| APPLICATION NO. | FILING DATE | FIRST NAMED INVENTOR | ATTORNEY DOCKET NO. | CONFIRMATION NO. |
|--|-------------|----------------------|------------------------------------|-----------------------------|
| 10/589,030 | 08/09/2006 | Paul Schalk | DC10028 PCT1 | 4159 |

Office Action Summary

DETAILED ACTION

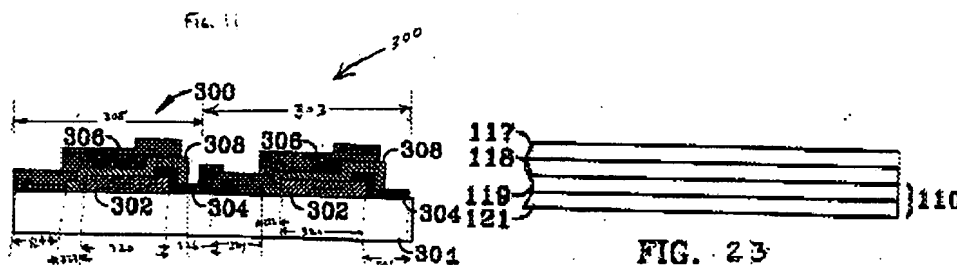
1. The title of the invention is not descriptive. A new title is required that is clearly indicative of the invention to which the claims are directed.
2. The disclosure is objected to because of the following informalities: page 15 includes a figure, the same cannot be present in the specification, it must be moved to the drawings section and numbered.

Appropriate correction is required.
